ORIGINATION FORM

Proposed Revisions to a Standard Plans Index
(Please provide all information – Incomplete forms will be returned)

Index Number: **649-031**
Sheet Number (s): 1 of 6
Index Title: Mast Arm Assemblies

MAST ARM ASSEMBLIES

ELEVATION AND NOTES

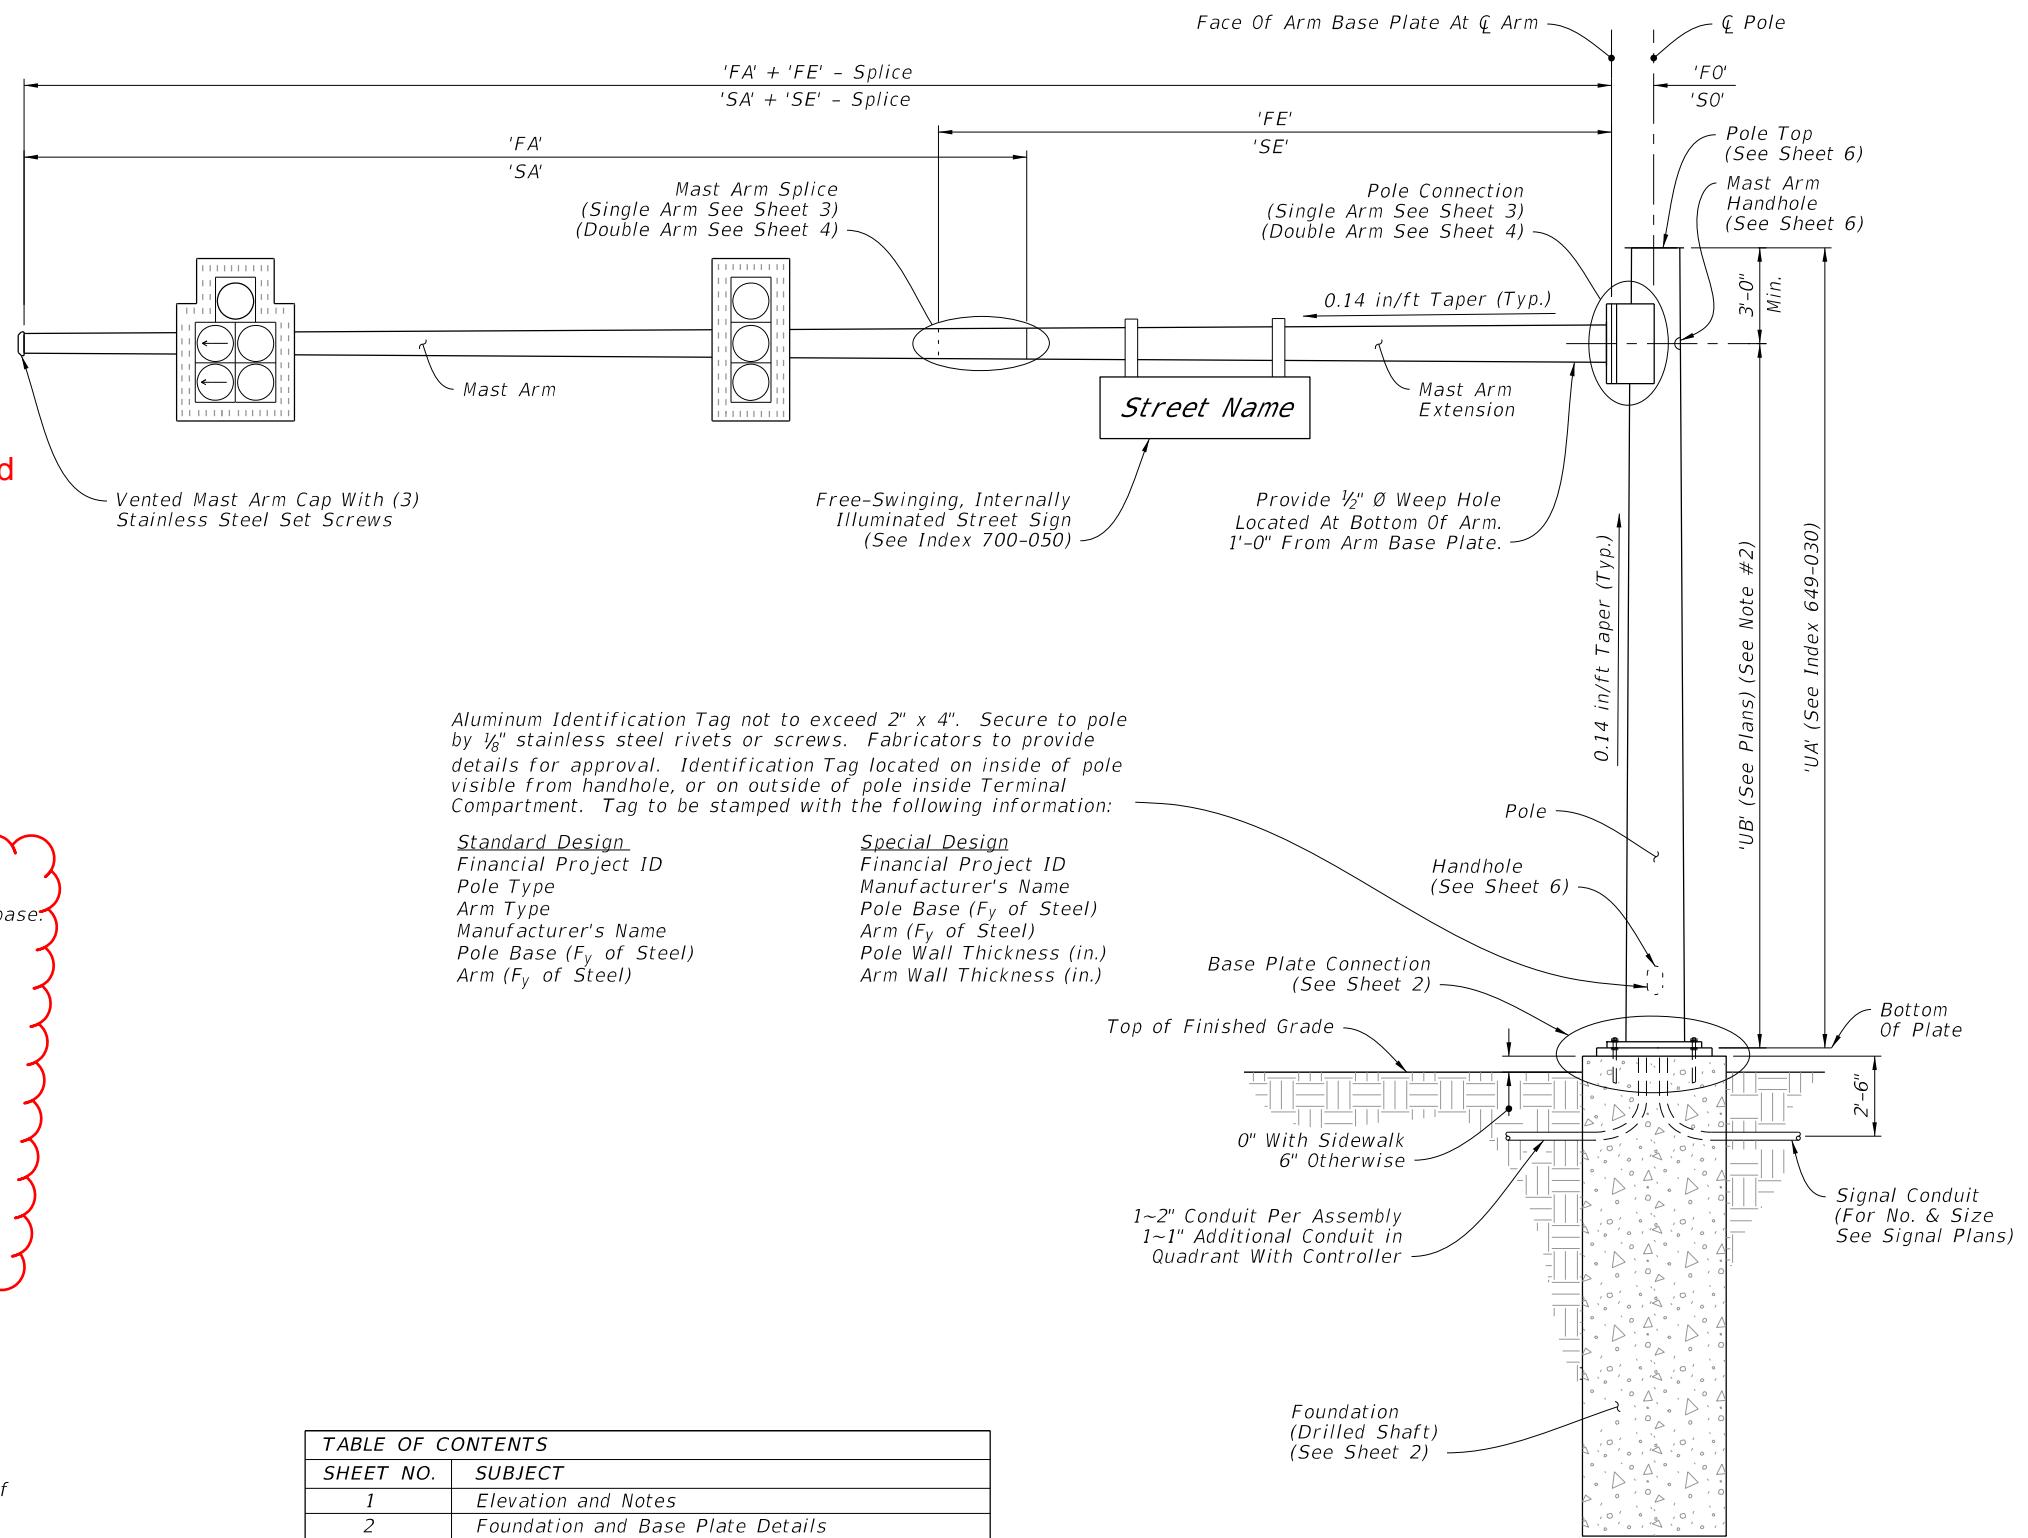
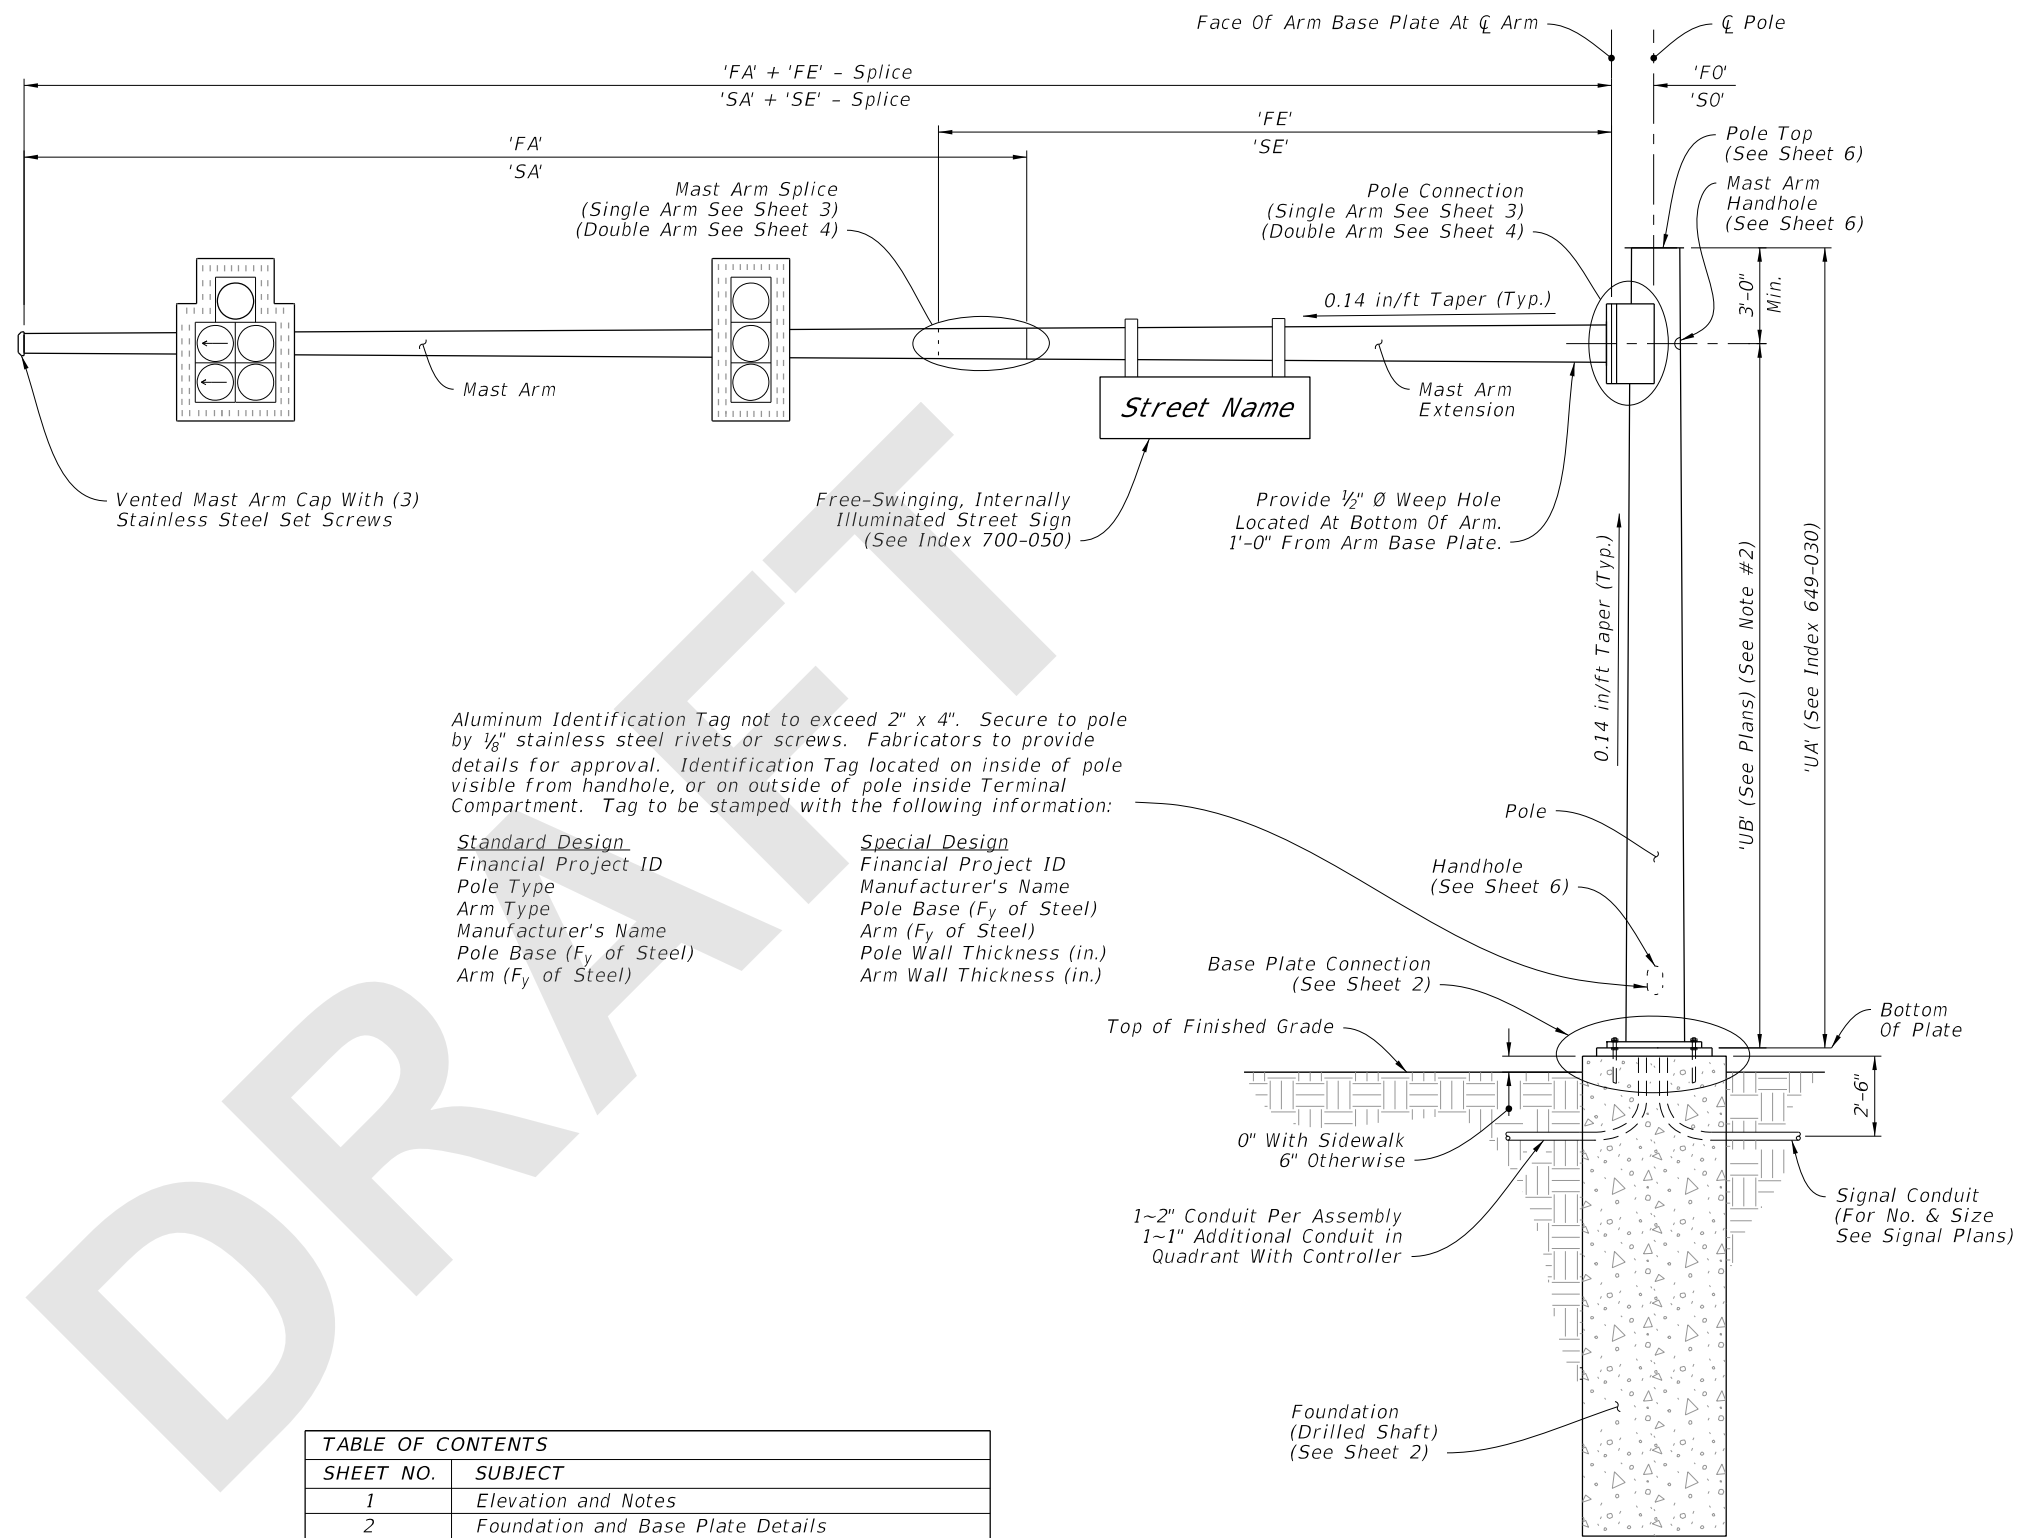
Sheet 1: Note 4 -Deleted Self-locking nuts; Changed Node D-a...High Strength "Hex Head" Bolts; Changed Note 5; Changed Note 6B add "including plate washers"

As part of consistency and clarity. Washers for standard bolts with nuts and plate washers require different galvanizing.

- ASTM A595 Grade A (55 ksi yield) or Grade B (60 ksi yield)
 - Steel Plates: ASTM A36
 - Weld Metal: E70XX
 - Bolts, Nuts and Washers:
 - High Strength Hex Head Bolts: ASTM F3125, Grade A325, Type 1

- All other steel items including plate washers ASTM A123
 - Construction:
 - Foundation: Specification 455 Drilled Shaft, except that payment is included in the cost of the Mast Arm.

ARM SPLICE

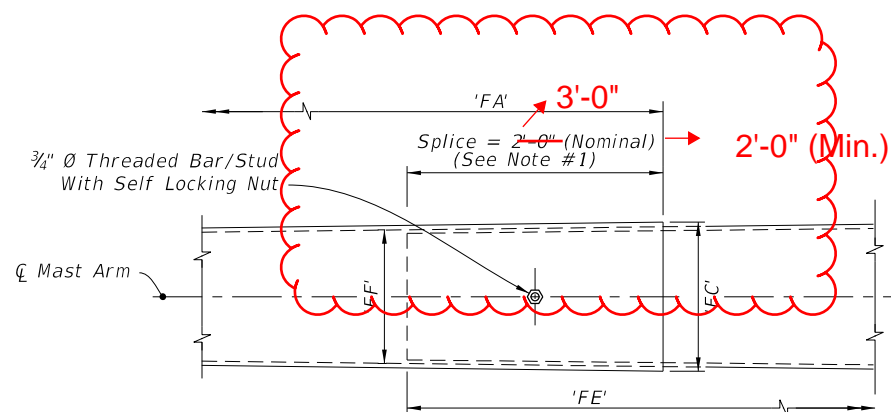
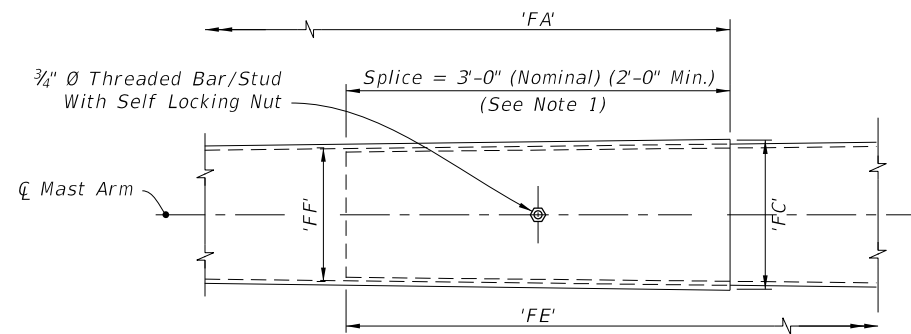
Sheet 3: Clarify Arm Splice length; Section D-D Clarified Inside Bend Radius.

SECTION D-D

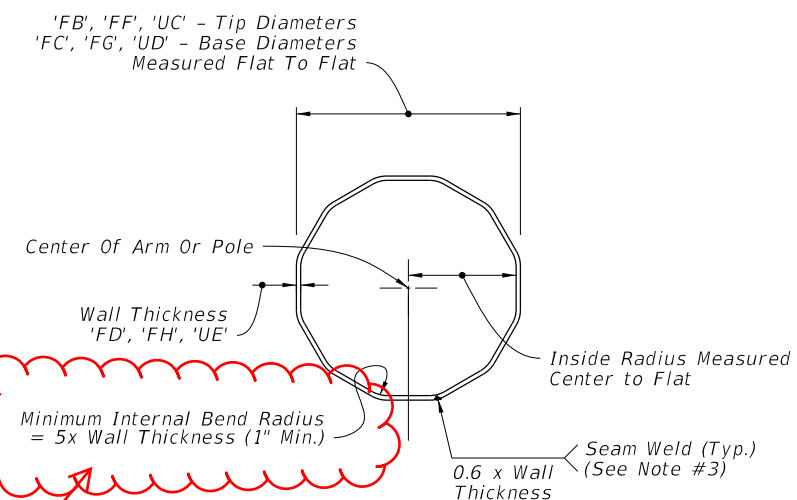
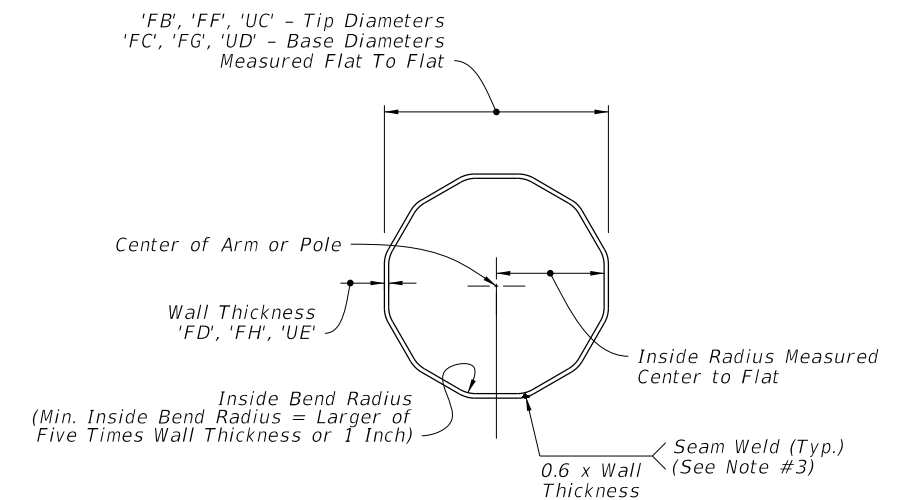
Changed
